Retford Circular Economy Project Environmental Statement Addendum – Volume 3 Technical Appendices

Technical Appendix 9.4: Environment
Agency Flood Risk Slide Deck

Project No.: 0695864

Hive response to flood risk matters raised
by the Environment Agency

Perimeter bunds - SSSI

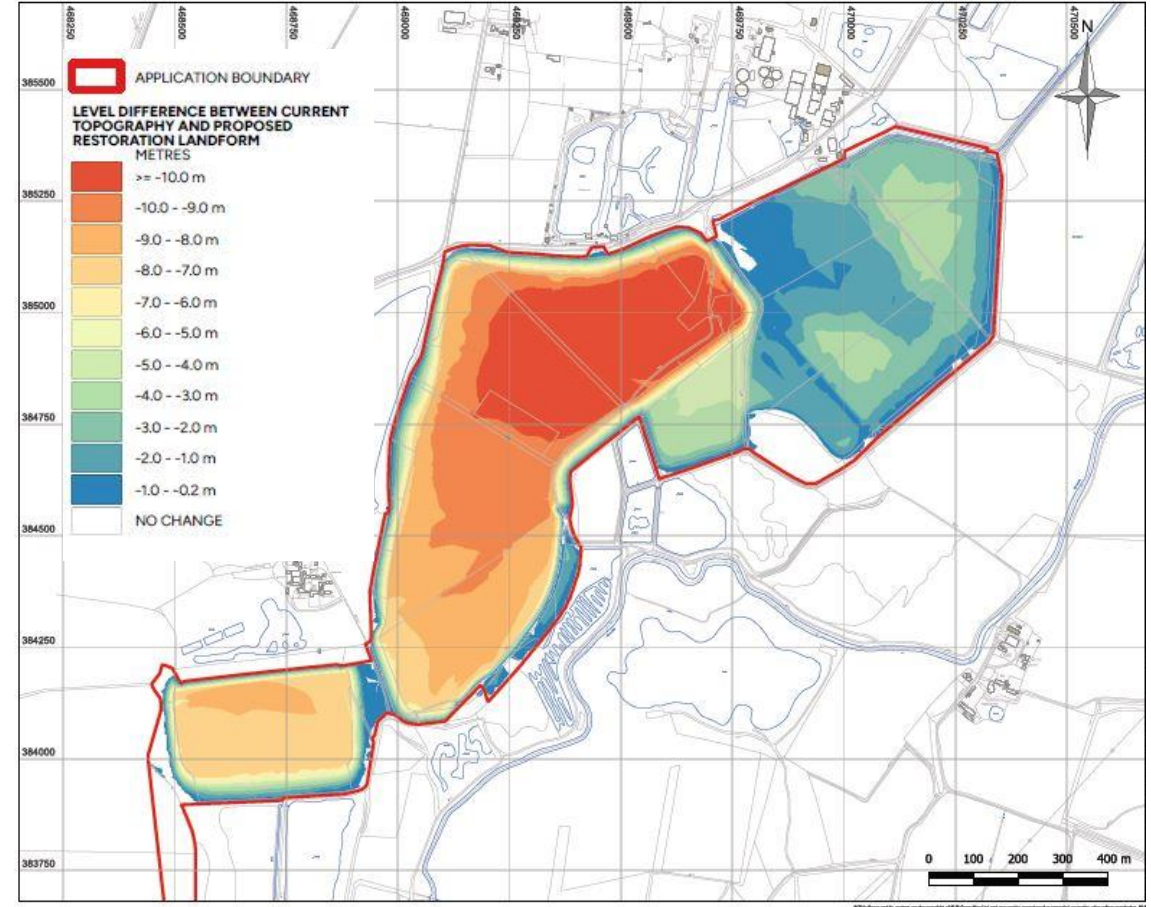
Apologies for the delay responding to you. We have examined the PowerPoint presentation and we broadly agree with the points, having looked into the modelling in some detail. Going forward, for the planning application we will therefore need to condition the location and dimensions of the "SSSI bund" shown highlighted yellow on the map below.

You will therefore need to submit to the LPA the cross sections of this bund from the presentation (slide 6) along with a plan showing the location of the cross-section B-BB and additionally a plan showing the length and location of the bund which will remain post-works, shown on a map (perhaps an annotation to slide 16 which isn't clear on the length of the raised SSSI embankment remaining after works are complete and restored).

The embankment at this location is approximately 65m wide at the base and is currently retaining 15m of PFA, approximately 6m of which is below water table. It forms part of the Idle Valley Nature Reserve SSSI, and as such will be fully retained in its present condition. The “as-built/ works complete” scenario will therefore be identical to the baseline condition.

Demonstrating that there is no pathway for floodwater to enter the site, or to bypass the site in the direction of Bellmoor Farm.

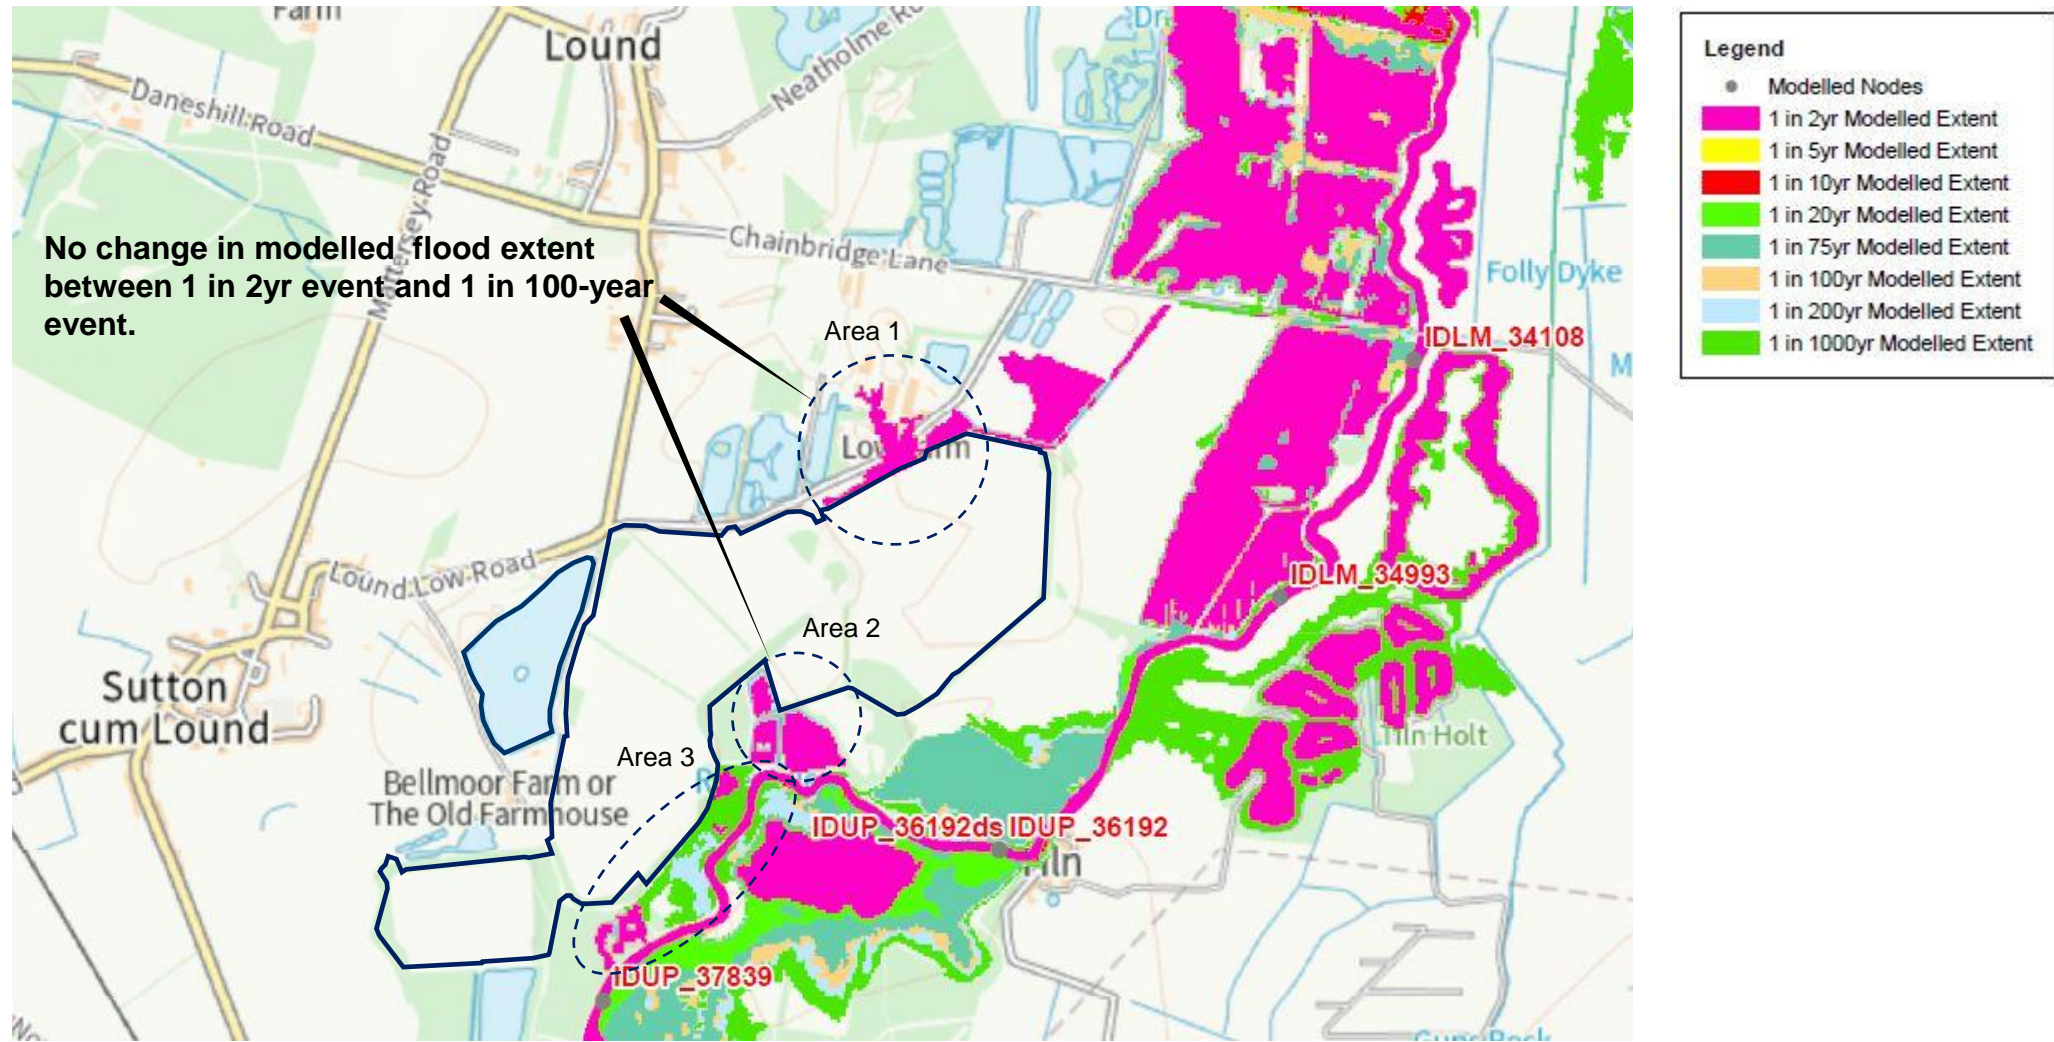
You will also note from the available LIDAR corresponding to section B-BB through the restoration plan that in the hypothetical scenario with this embankment removed entirely there is no route for water to enter the site in a 1 in 100-year +30%CC event, or to bypass the site towards Bellmoor Farm, due to existing high ground at 10m AOD (the peak flood level being 9.6mAOD).

1%AEP + 30%CC peak water levels - Area 1

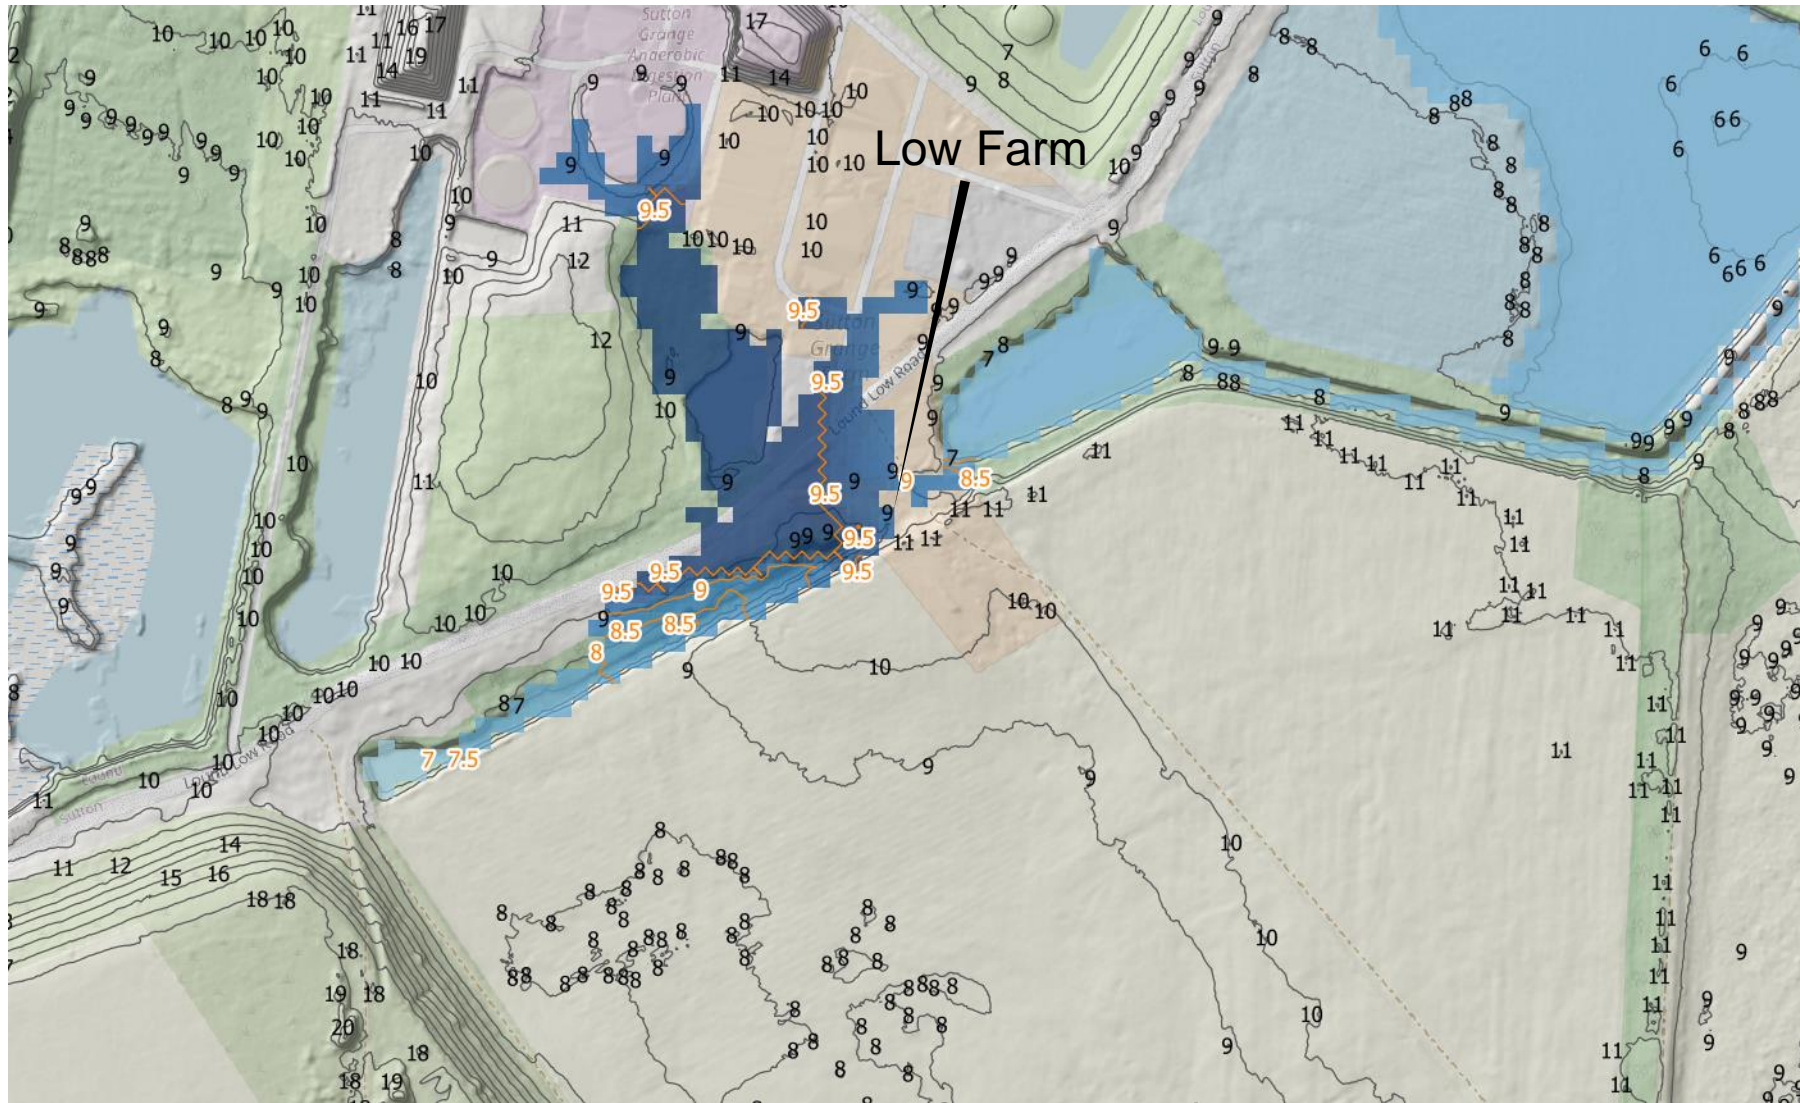
What stands out from our initial inspection of the model files and supporting River Idle 2020 Model Update Report is that an initial water level condition was introduced in the 2D model to fill low spots in the topography, so that any available storage is removed at the start of each model

run. You can see from slide 9, that in Areas 1 and 2 peak flood extents don't change between the 1 in 2 and the 1 in 1000-year scenarios. To confirm this, we have superimposed the peak flood levels and flood extents for the 1 in 100+30%CC, 1 in 20-year and 1 in 5-year flood events on top of the LIDAR data in the vicinity of Low Farm; and as you will see from flicking between the results the peak water levels are not influenced at all by water levels in the river or the adjacent floodplain.

WSP have looked closely at the initial water level polygons in the GIS layer that was introduced to establish the initial water level condition in the 2D model domain, and this confirms that the flood levels reported for Areas 1 and 2 in all flood events up to and including the 1 in 1000-year flood event are an artefact of the initial water level condition set prior to running the model. There is no flow pathway from the River Idle to the Proposed Development, other than along the section of embankment (identified as Area 3) which lies within the Idle Valley Nature Reserve SSSI and as such will be fully retained in its present condition.

There is no flow pathway to the site from the River Idle in flood events up to and including the 0.1%AEP flood. Peak water levels in these two areas are an artefact of the initial water level condition introduced to fill low spots in the topography prior to running the model.
